UNITED STATES PATENT AND TRADEMARK OFFICE

APPLICATION NO.	FILING DATE	FIRST NAMED INVENTOR	ATTORNEY DOCKET NO.	CONFIRMATION NO.
09/421,575	10/20/1999	ICHIRO KASAI	15162/00910	4346

Office Action Summary

DETAILED ACTION

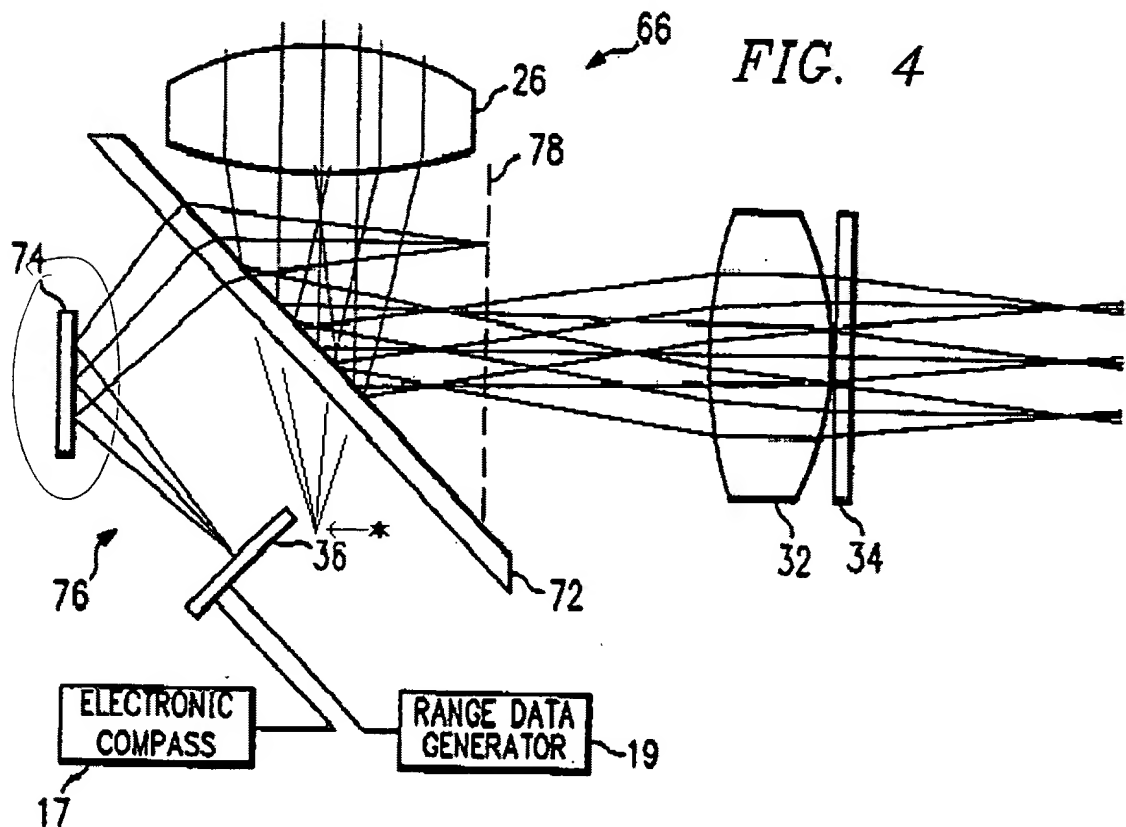
a hologram combiner (Fig. 4, 72) comprising a reflective-type hologram (a reflective- *and* transmissive-type, or transflective-type, actually) and having an optical power for constructing an equivalent surface (78) which is optically equivalent to the image surface at a different position than the image surface as viewed from the pupil (See annotated Fig. 4 below: esp. <---*); and

3. Applicant's arguments filed 24 June 2002 have been fully considered but they are not persuasive. In addition to the Response to Arguments set forth in the outstanding Final Rejection (duplicated below), the Examiner would simply like to add that, with regard to independent claims 1 and 10, Wallace can fairly be viewed as meeting Applicant's recitation in these claims of, in pertinent part, "...a hologram combiner comprising a reflective type hologram and having an optical power for constructing an equivalent surface which is optically equivalent to the image surface at a different position than the image

surface as viewed from the pupil." That this is the case can be seen by reference to the annotated Fig. 4 of Wallace provided above. In this case, the equivalent surface is 78, and the image surface (virtual) is as depicted by "<---*." As clearly depicted, equivalent surface 78 is both optically equivalent to the image surface (identified by "<---*") and at a different position than the image surface as viewed from the pupil.

As is clearly set forth in Fig. 4 of the Wallace reference, the hologram combiner (72) is both reflective and transmissive (read: transfective): reflecting the light from the image and transmitting the light from the information display device (76). As is clearly set forth in the rejection of claims 1 and 10 above, one of ordinary skill in the viewing optical system art would certainly consider the rearrangement of the relative positions of the information display device and light from the image (including, of course, lens 26), one to the other, for at least the purpose of, for the sake of example, increasing the brightness of light from the information display device via reflection from said hologram combiner, as opposed to the brightness of same realizable via transmission through said hologram combiner.

The hologram combiner (72) taught by Wallace not only has optical power (as can clearly be seen in Fig. 4, in which light diverging from folding mirror (74)--that is, light from said image display device--is made to converge, following its transit through said hologram combiner, a result that could only be achieved if said hologram combiner had non-zero optical power), but focuses light from said information display device at plane 78, which is "optically equivalent" to the image surface at a different position than the image surface as viewed from the pupil in the same manner as that constructed by Applicant's hologram combiner. It is noted that the manner in which something can be described as being both "optically equivalent" and "at a different position than the image surface as viewed from the pupil" is met by Wallace by broadly interpreting "optically equivalent." In addition, as was noted in the previous Office action, Fig. 4 clearly depicts light from the information display device focussing at a different position (i.e., to the left of 78) than light from the imaging lens 26 (which focuses to the left of 78, denominated "common" or not) as viewed from the pupil (although the physical separation between focused information display device light and that from the imaging lens (read: image) is not set out in Wallace).
